934.126 GL Aurelia

Artform Home Plans

First Floor

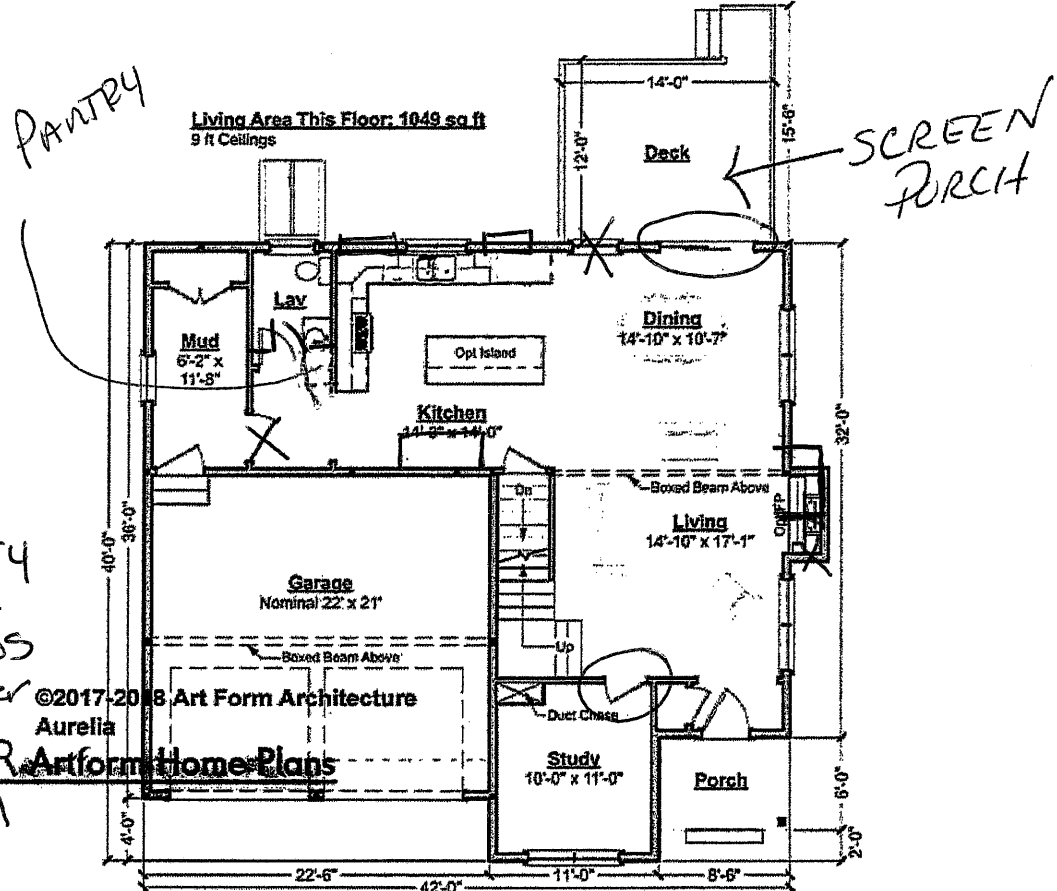
1. Remove mud Room Door
2. Shorten 1/2 Bath - ADD Pantry
3. no upper cabinets on Back wall - 3 double mul windows
4. Remove window next to slider
5. Reverse active panel on Slider
6. center Fireplace on 32' wall
7. Pocket door in study

Second Floor

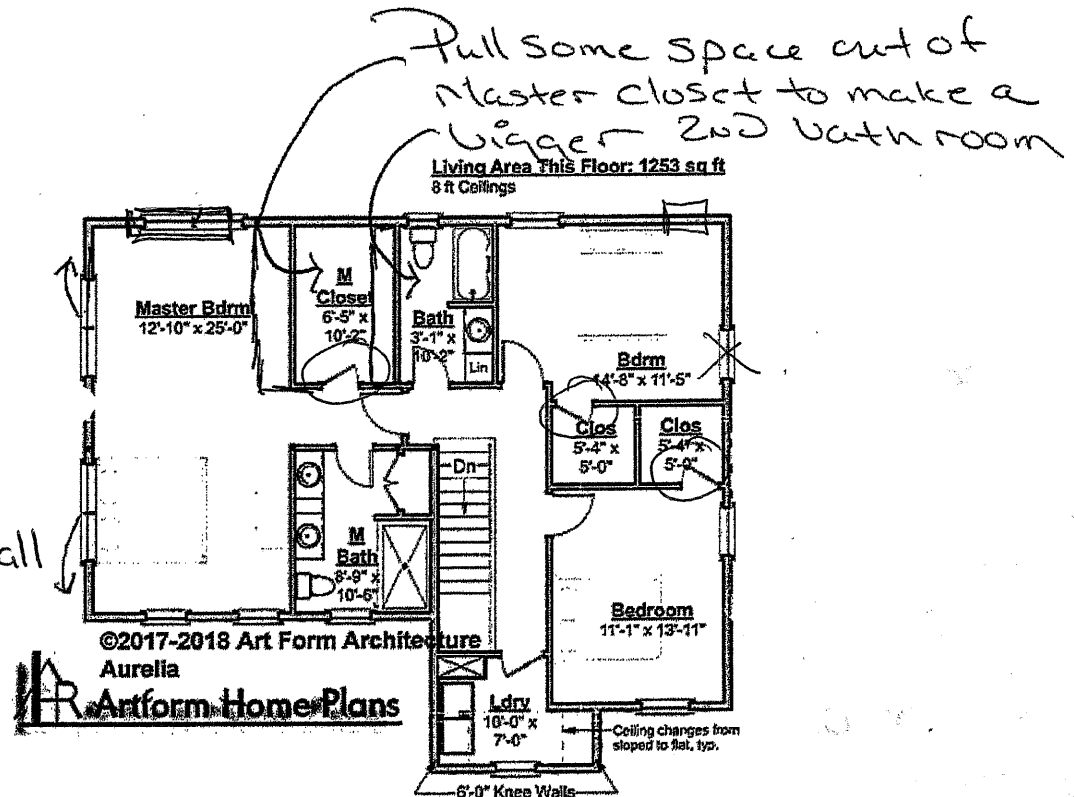
8. make Bath 1' Larger
9. center window on Back wall
10. 3 closets - pocket doors
11. move window in Back bedroom TO Back wall
12. move Front Bedroom window as far forward as possible
